EASTERN CORRIDOR SEGMENTS II AND III (PID 86462)

VILLAGE OF NEWTOWN FOCUS AREA

ADVISORY COMMITTEE MEETING NOTES

MEETING #4 NOTES

Additional Westbound Lane at Church and Main Intersection

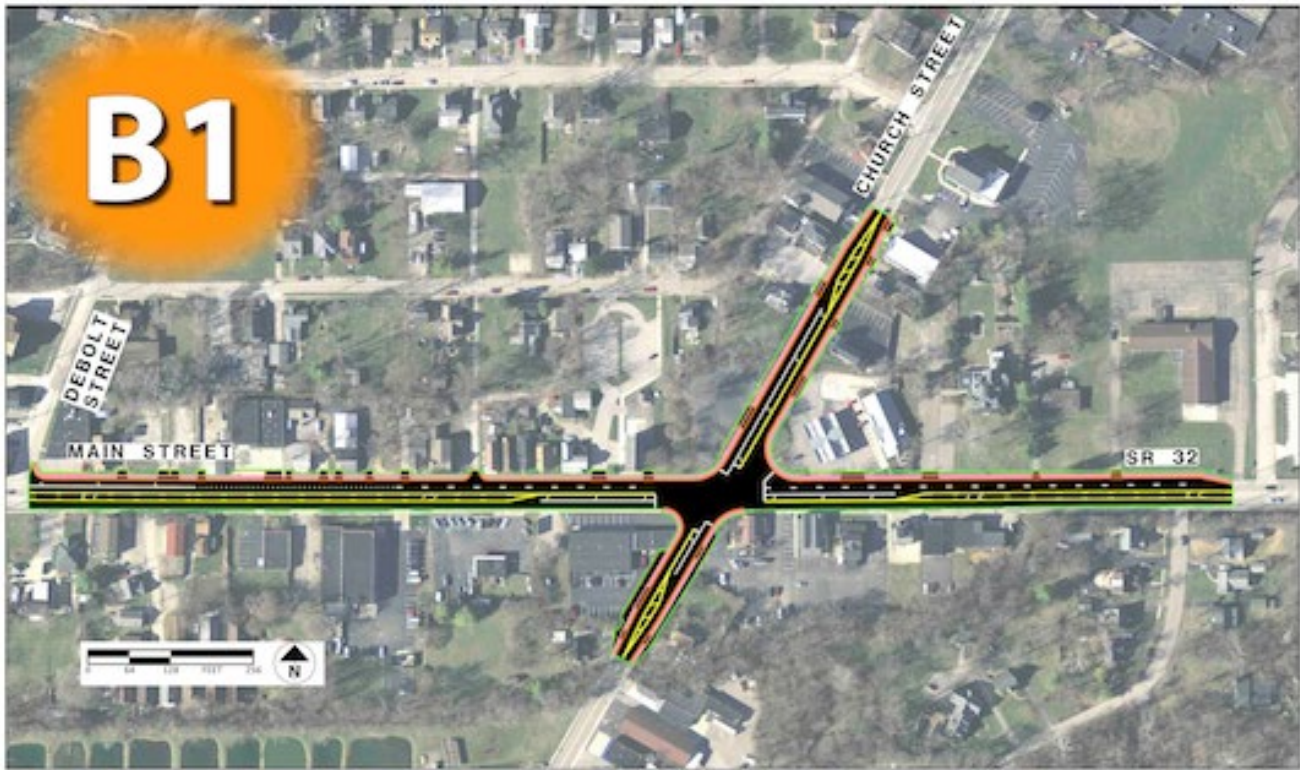
- Traffic delays in the area are caused by signalized intersections.
- This concept can be implemented without building acquisitions. The closest building to the road is located at 6826 Main Street, which would abut the sidewalk.

- ODOT prepared a series of typical sections that depict how the proposed road widening project would compare with the existing road, shoulders and sidewalks at various locations along the roadway. These sections are shown on the concept exhibit page.

- The 11’ lanes on the side of the road are really 10’ lanes with a one foot shoulder. The shoulders would not be marked.
- The additional eastbound lane on SR 32 would end as a right turn only lane at Debolt.

- Poles on the south side of the road would not be moved.
- Newtown just posted No Parking signs on SR 32.
- Does the right lane on westbound SR 32 need to be as long as proposed? It is designed to be 1000 ft long, which is ODOT’s target length for through lanes.

- How much benefit is the right through lane on westbound Main Street since it disappears east of Church Street?
 - Traffic turning right onto Church Street is not particularly heavy; however, vehicles turning right into the UDF parking lot can block traffic flow.

- Conservative estimates are that 10 percent of drivers would use the right lane, even though they have to merge back before Debolt. Though a small percentage, it impacts the overall intersection efficiency, translating to a 40 to 60 percent reduction in travel delays for everyone.

- Modifications to the SR 32/Church Street intersection would alter the streetscape in the area. This may not be desirable for some residents. One Committee member also expressed concern that widening would

- make the central business district feel less walkable. ODOT suggested that decorative concrete could be used adjacent to the curb to give a better feeling of separation from traffic.
- Newtown may be more interested in finding a middle ground that would allow vehicles to move through the intersection better. ODOT suggested there could be an opportunity to stripe the curb lane as additional parking during non-peak hours.
 - Length of widening on Church at the intersection may not need to be as far as shown in concept drawing. Perhaps widening up to a length of 4 to 5 cars is sufficient.
 - No additional comments were received following the 9/6 meeting.

- Approximately 59% of public responses received about this project was either Strongly Support (31%) or Like (28%). Approximately 6% Strongly Opposed and 6% Disliked the project. The remaining responses (31%) were Neutral [see the Public Feedback Ratings Summary on the I-6a (B1) exhibit page].

- The Village of Newtown asked to see this data analyzed based only on responses provided from people who live in the 45244 (Newtown) zip code. It’s their impression that residents are split fairly evenly between the improvements being proposed.

- A subsequent review of the data showed that of the 24 respondents who reported living in the 45244 zip code, 38% (9 people) Strongly Supported and 33% (8 people) Liked the project; 8% (2 people) Disliked and 4% (1 person) Strongly Disliked the project; and 17% (4 people) were Neutral.

- The Sierra Club mentioned that while they support plans that improve pedestrian and bicycle connectivity, they do not support plans that would lead to an increase in vehicle miles traveled or would reduce bike/pedestrian connectivity, such as adding a new lane on SR 32 through Newtown.

- It was suggested that if this project were to be completed, walkability can potentially be addressed by designating the second lane as a parking lane for the majority of the day, but use it as a travel lane during peak hours.

- There was concern that people may not use the second travel lane even if one is made available. However, this could perhaps be addressed by establishing the new process as soon as the new lane is created.

- Include in the Implementation Plan as a **high** priority.
- Prepare a public feedback summary report focused on responses provided from residents of the 45244 zip code.

**Roundabout at
Round Bottom and Valley
Intersection**

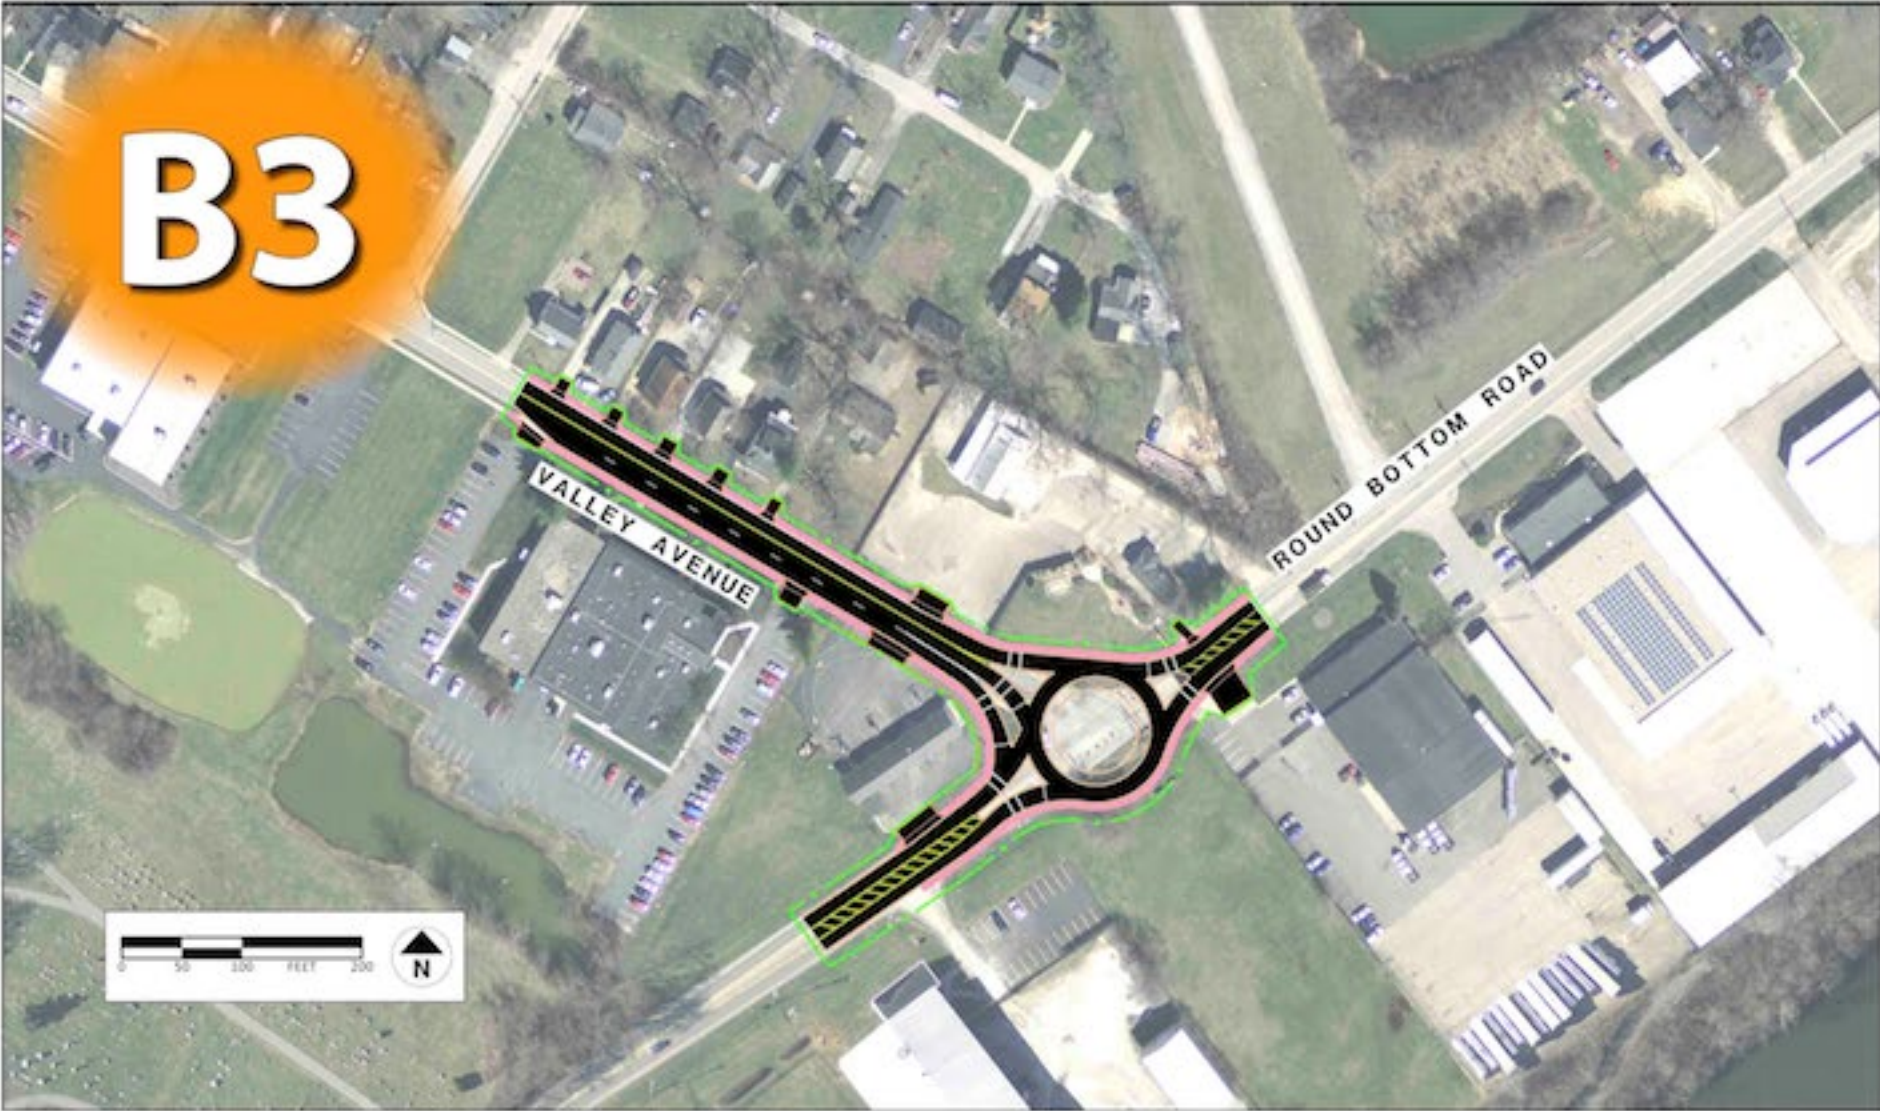
- Study results indicate that this alternative shows better operations in terms of delay and safety and costs less when compared to Concept I-8a.
- The roundabout is designed to manage truck traffic and can accommodate the large-size trucks from nearby businesses and school buses.
- A fourth leg could be added to the roundabout to provide access to the businesses located on the southeast side of the intersection (Robbins Flooring and Hazmat Environmental Group). Adding a fourth leg would increase the cost bringing it closer to concept I-8a, but the benefits of the roundabout still outweigh those of concept I-8a.
- No additional comments were received following the 9/6 meeting.

- Some concerns regarding speed on Valley can be addressed by slowing traffic down.
- Some committee members expressed concerns regarding trucks using the roundabout. ODOT explained that the roundabout would be designed to accommodate truck use.
- The committee agreed that this concept should be designated as a medium priority.
- It was suggested that a right-turn signal be added at the Round Bottom and Valley intersection prior to (or instead of) construction of a roundabout. Newtown is moving forward with the right-turn signal

- Include in the Implementation Plan as a medium priority.
- Reassess traffic after signal upgrades to determine need.

Roundabout at Church and Valley Intersection

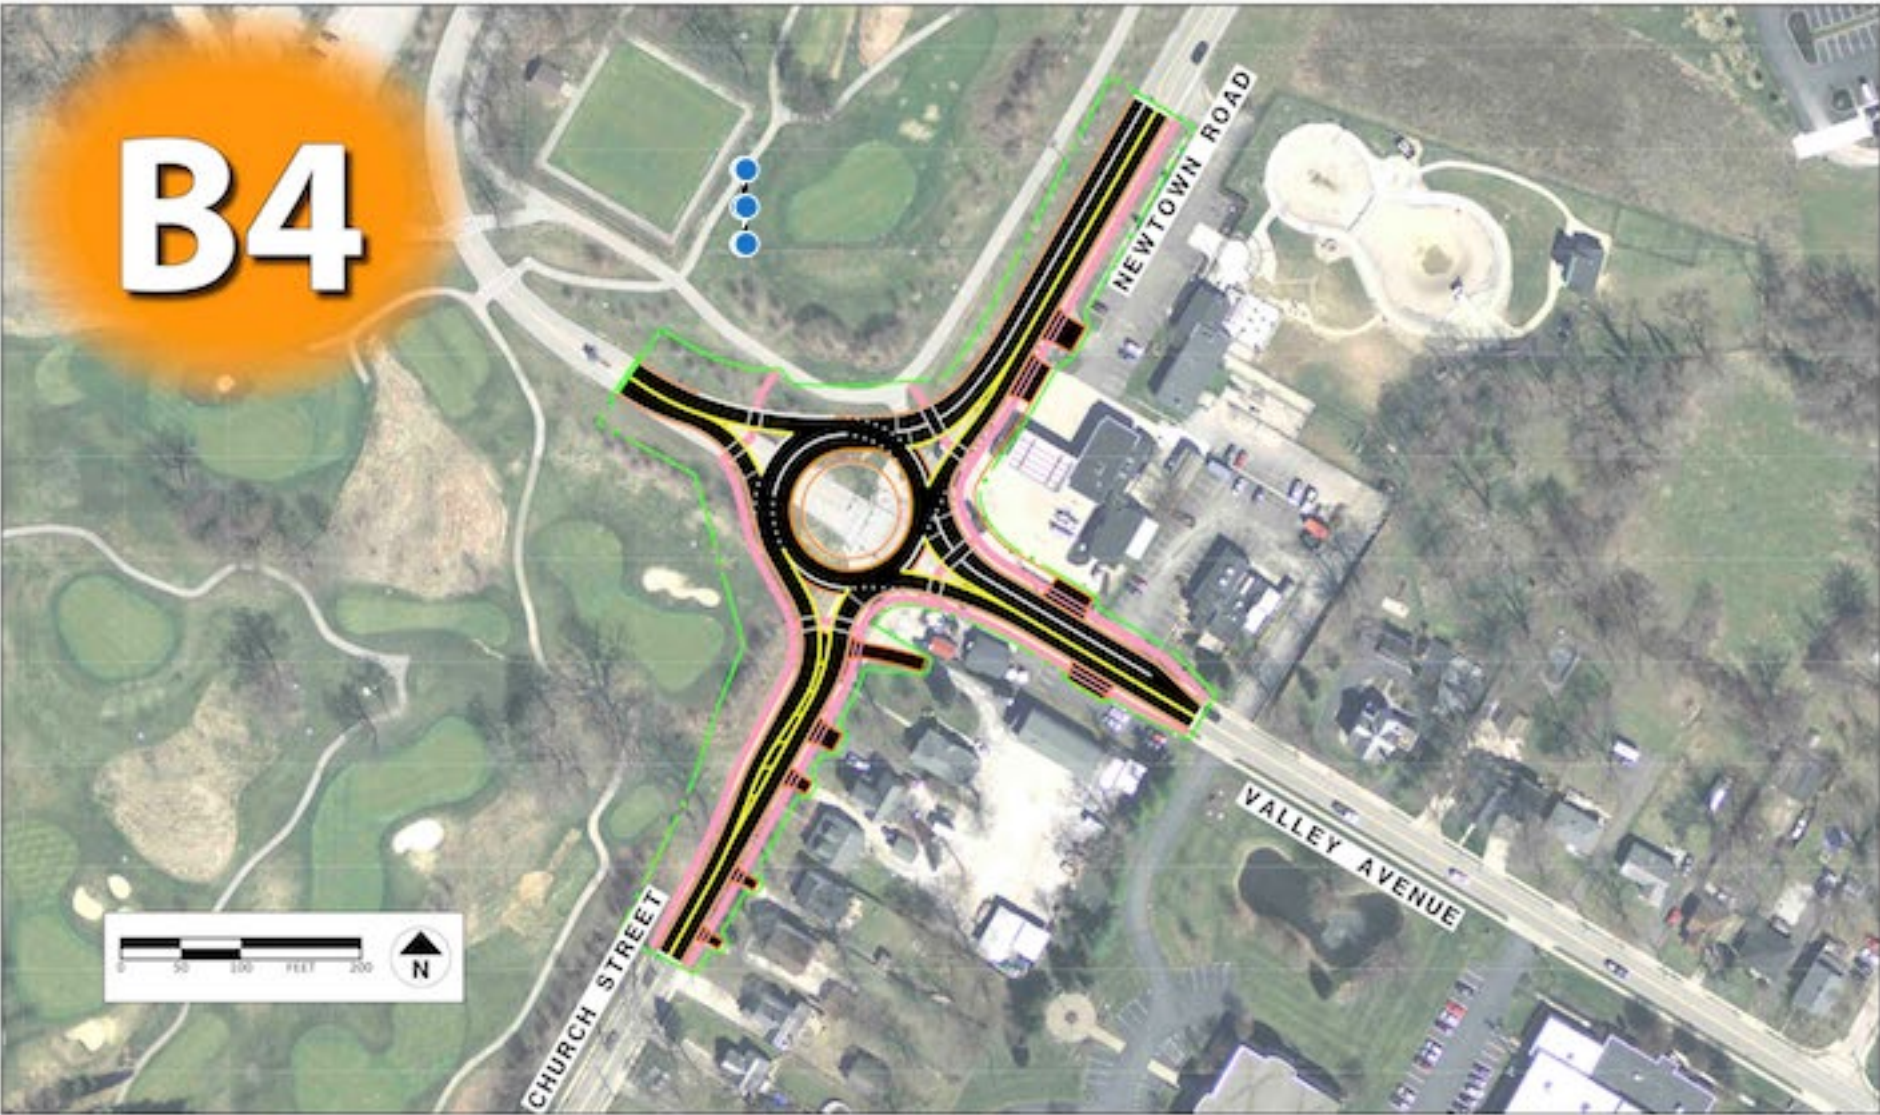
- Concepts I-10b and I-10c are alternatives for accomplishing the same goal.
- Because roundabouts reduce travel delays and offer improved safety, this is probably the best alterative of the two.
- The concept would make it more difficult to access the Growler Stop, but there are options available (such as creating a new access point off of Church Street).
- A new restaurant is going to be established at the old Lazlo’s location. Access also needs to be provided to this new restaurant.
- The green lines on the concept exhibit indicate construction limits. These limits would impact the bike path on the west side of Newtown Road during construction. Temporary right-of-way may be required during construction.
- Construction may impact the Little Miami Golf Course.
- No additional comments were received following the 9/6 meeting.

- This concept was presented as B4 at the October Open House meetings.*
- Some concerns regarding speed on Valley can be addressed by slowing traffic down.
 - Some committee members expressed concerns regarding trucks using the roundabout. ODOT explained that the roundabout would be designed to accommodate truck use.
 - The committee agreed that this concept should be designated as a medium priority.
 - Sierra Club expressed some concern about the impact a roundabout at

this location would have on the golf course/park and noted that these impacts should be considered most closely before any decisions are made.

- Include in the Implementation Plan as a medium priority.
- Reassess traffic following implementation of planned signal upgrades to verify if need remains.

Adjust Grade at Railroad Crossing on Church

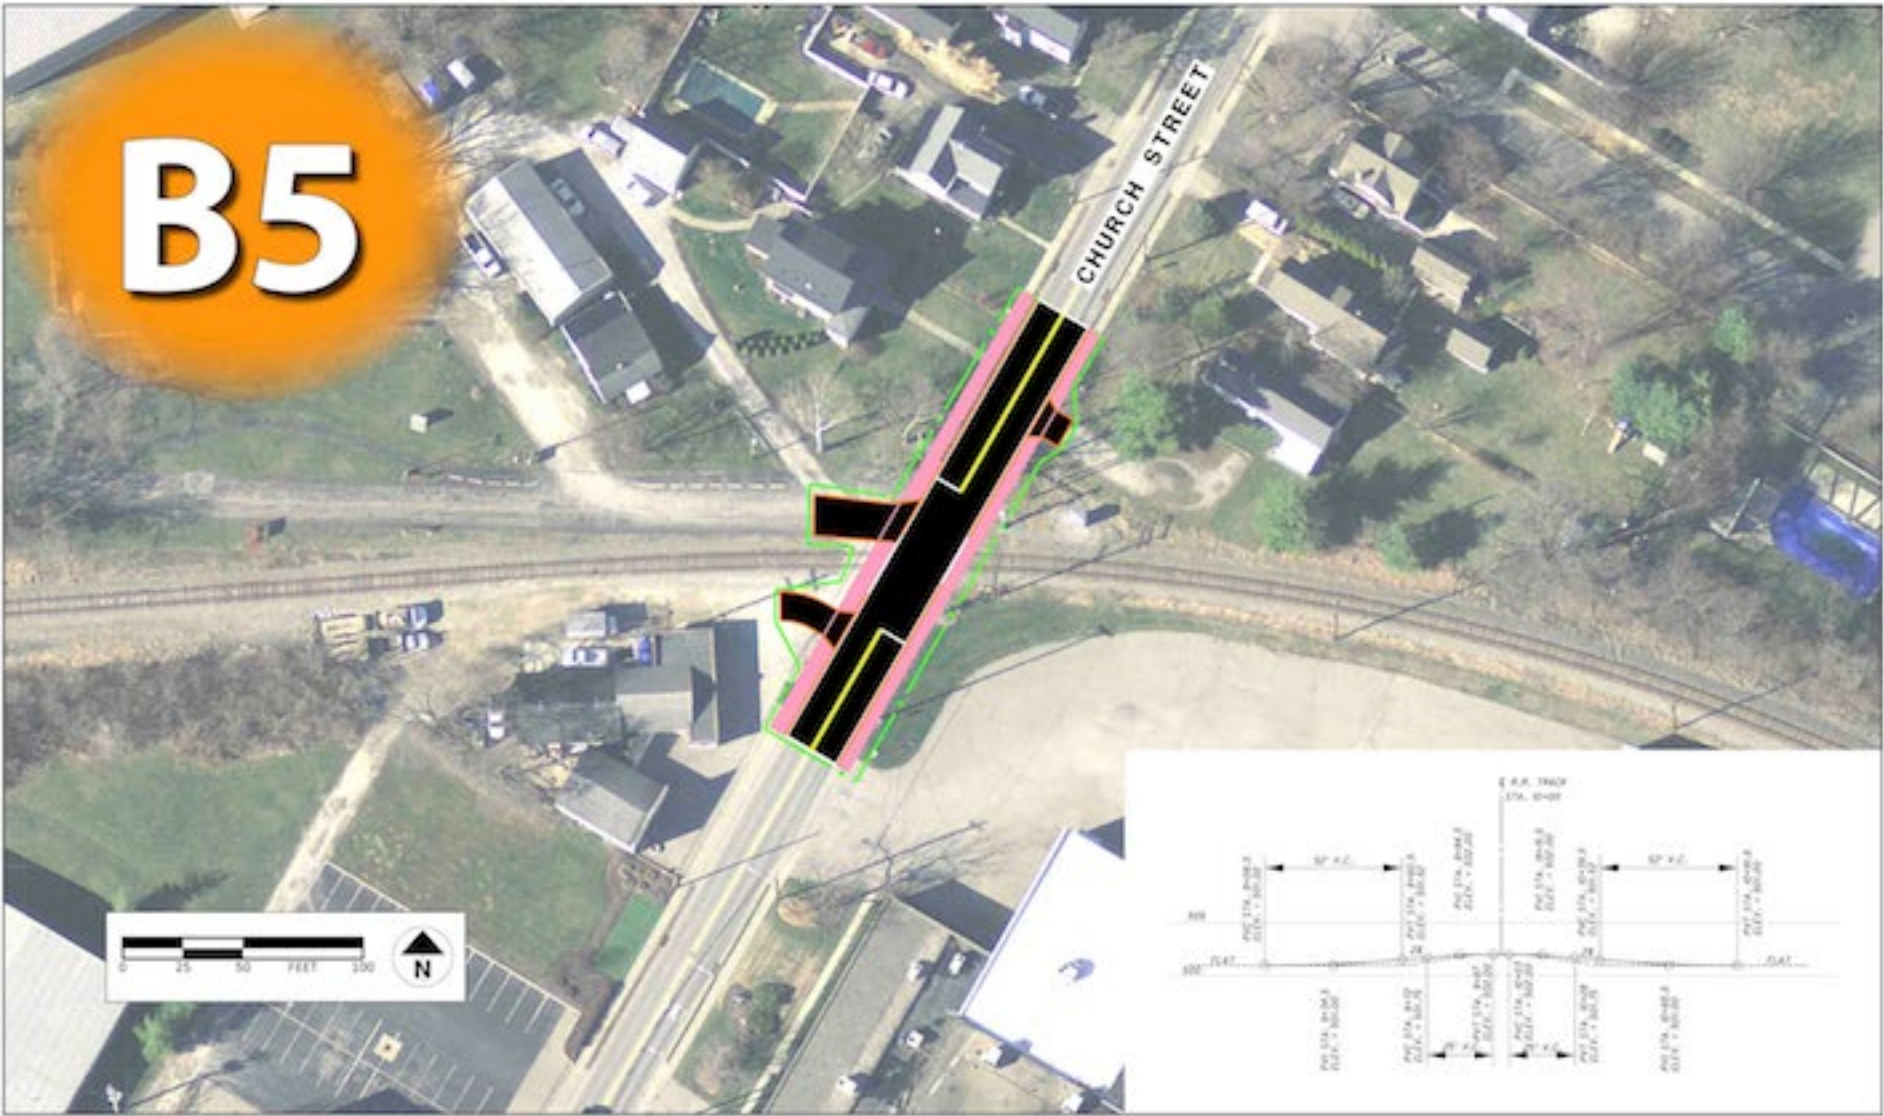
- The committee had anticipated that there would have been stronger support from the public for this concept. There was speculation that people may like how the current grade acts as a traffic calming measure.
- A committee member asked if the increased bus use of this crossing by Forest Hills Schools after the relocation of the school bus compound to Round Bottom is an issue. Forest Hills Schools responded that the grade of the crossing is not a problem for their busses.
- The committee agreed that this concept should be designated as a medium priority.

- This concept would correct the grade of the roadway (flatten the existing bump) at the railroad crossing on Church Street.
- The concept does not address a primary need.
- No additional comments were received following the 5/16 meeting.

- This crossing will be a primary route for school buses accessing the new transportation depot on Round Bottom Road.
- No additional comments were received following the 9/16 meeting.

- Public feedback received leans toward neutral to positive : 18% Strongly Support, 35% Like, 35% Neutral, 7% Dislike, 4% Strongly Oppose [see Public Feedback Ratings Summary, next page]

- Include in the Implementation Plan as a low to medium priority.
